Final plat  
SUBDIVISION REPORT

SUBDIVISION COMMITTEE  
METROPOLITAN AREA  
PLANNING COMMISSION

S/D No.: 84-39

Name: Toben Second Addition

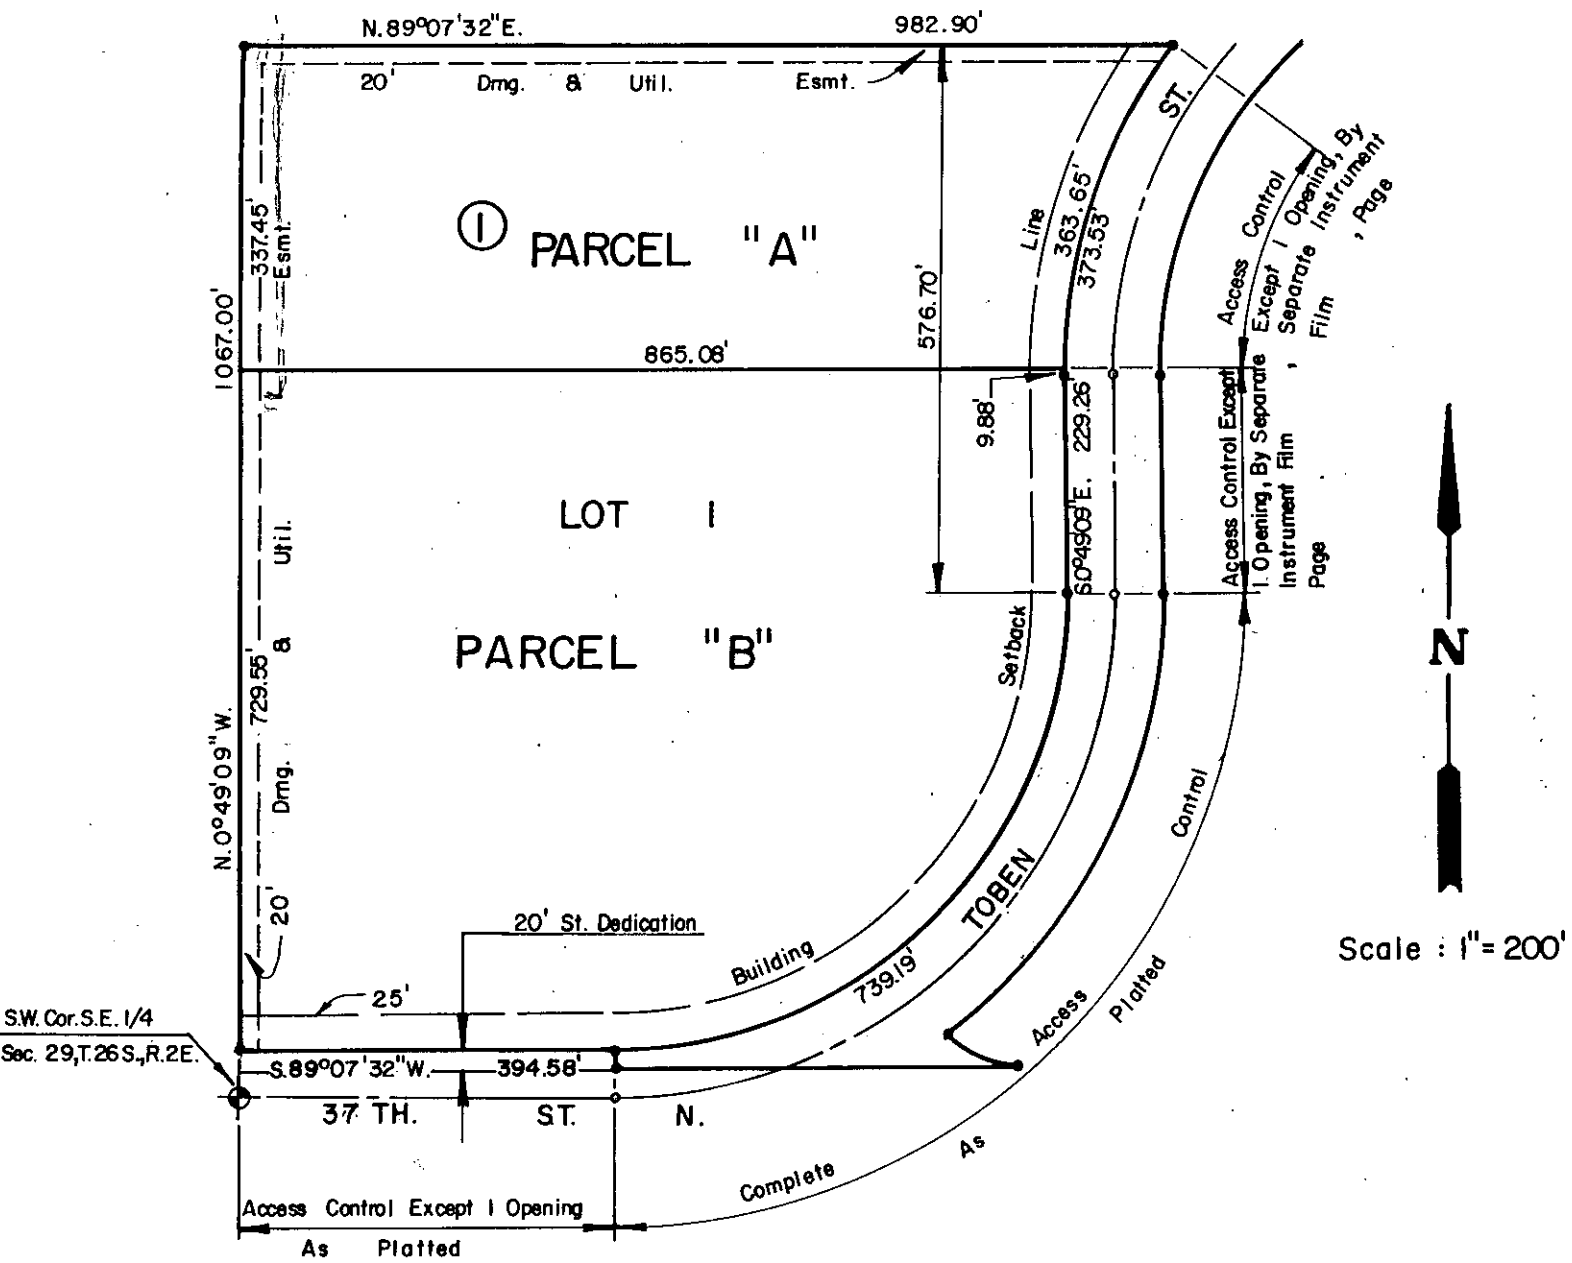
- A. The south line of this plat shall be the section line. No right-of-way for the south half of 37th Street can be included in this plat.
- B. The street name "37th Street North" shall be for only the portion of street running in a true east-west direction. The name "Toben Street" shall commence where the street begins to curve north from 37th Street.

- C. The plattor's text shall dedicate the streets and reference the access controls.
- D. Access control except for 2 openings shall be labeled adjacent to the east line of the north half of Lot 1.

- E. The applicant should consider petitioning for the paving of 37th/Toben/39th to a 29-foot standard from the west line of this plat to Webb Road.
- F. The applicant shall guarantee the paving of 37th Street to industrial standards from Webb Road to its intersection with Toben Street.

- G. The applicant shall guarantee extension of water and sanitary sewer to serve this lot.
- H. The City Engineer's representative shall be prepared to comment on the drainage plan for this property. Any necessary drainage improvements shall be guaranteed by the applicant.

- I. The applicant shall submit an avigational easement and restrictive noise covenant for this property. The applicant is hereby advised that this property is within Zone A of the Airport Hazard Zoning Ordinance. Any structure exceeding 25 feet in height will require an airport hazard zoning permit.
